TECHNICAL SERVICE BULLETIN

DATE ISSUED	MODEL YEAR(S) AFFECTED	MODEL(S) AFFECTED	TSB #
04/03/2013	2009-2013	Essex, King Aire	403
BRAND			TYPE
All <input type="checkbox"/>	American Star <input type="checkbox"/>	Mountain Aire <input type="checkbox"/>	All <input type="checkbox"/> TT <input type="checkbox"/>
Cypress <input type="checkbox"/>	Dutch Star <input type="checkbox"/>	Kountry Aire <input type="checkbox"/>	FW <input type="checkbox"/> CA <input type="checkbox"/>
Northern Star <input type="checkbox"/>	Kountry Star <input type="checkbox"/>	Essex <input checked="" type="checkbox"/>	DP <input checked="" type="checkbox"/> DB <input checked="" type="checkbox"/>
Scottsdale <input type="checkbox"/>	King Aire <input checked="" type="checkbox"/>	London Aire <input type="checkbox"/>	
All Star ME <input type="checkbox"/>	Ventana <input type="checkbox"/>	Bay Star <input type="checkbox"/>	
<input type="checkbox"/> Air Conditioning & Heating <input type="checkbox"/> Appliances & Accessories <input type="checkbox"/> Cabinets & Furniture <input checked="" type="checkbox"/> Chassis Components <input type="checkbox"/> Construction Components <input type="checkbox"/> Electrical Components <input typ

FIG. 2-1

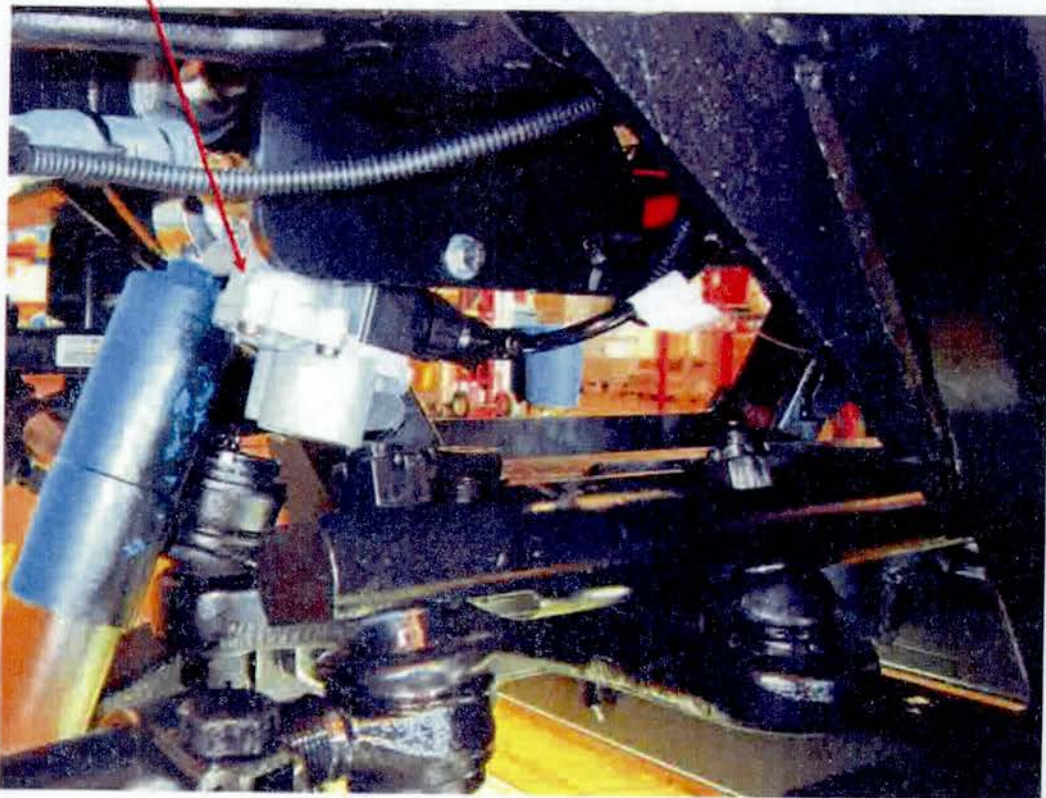
CONDITION: When the steering wheel is turned, the relay rod on the IFS may interfere with the ABS modulator valve.

1. Locate left and right ABS modulator valves on front IFS suspension. Refer to FIG. 2-1.

CORRECTION: Add spacer behind ABS modulator valve.

FIG. 3-1

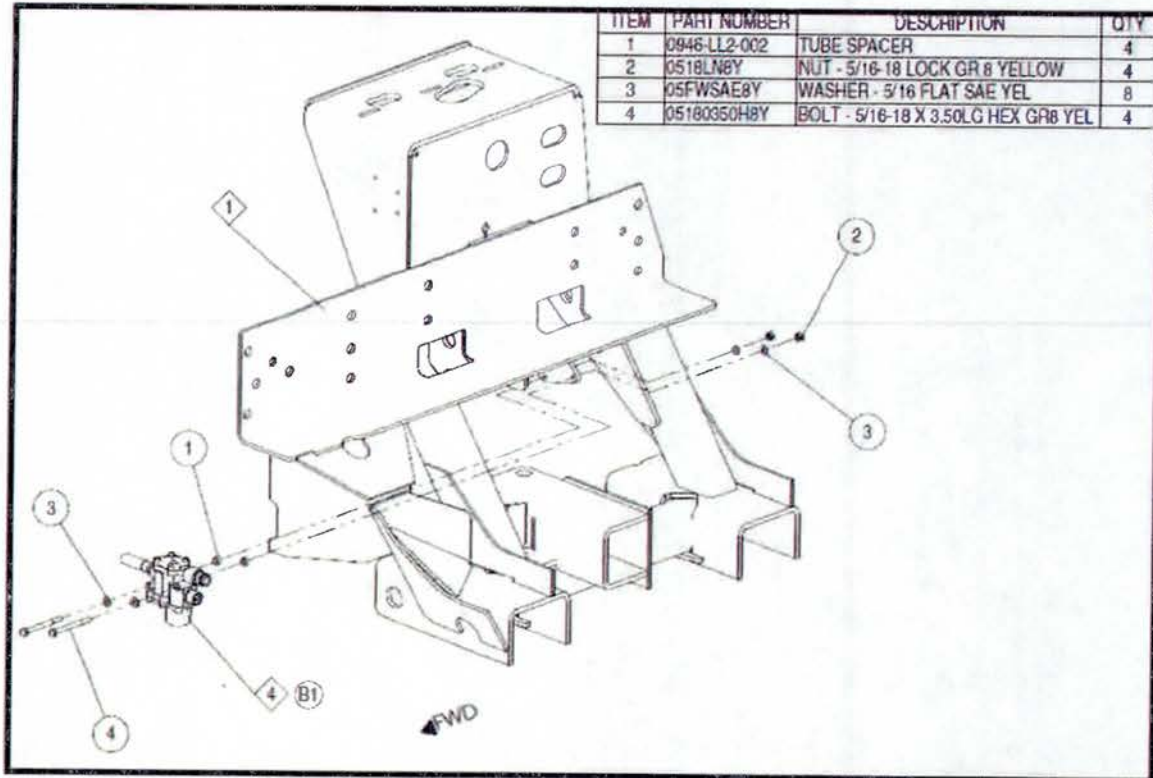
2. Remove (2) 5/16 in. bolts, (4) washers, and (2) nuts that mount ABS modulator valve to suspension. Retain washers and nuts for reuse. Refer to FIG. 3-1.

NOTE: Do not remove airline or brake drop hose from valve.

3. Install spacers between ABS modulator valve & mounting plate. Refer to FIG. 3-1.
4. Install new bolts, retained washers, and retained nuts. Torque nut side to 15 lbs. ft.
5. Repeat steps 2 through 4 for opposite side.
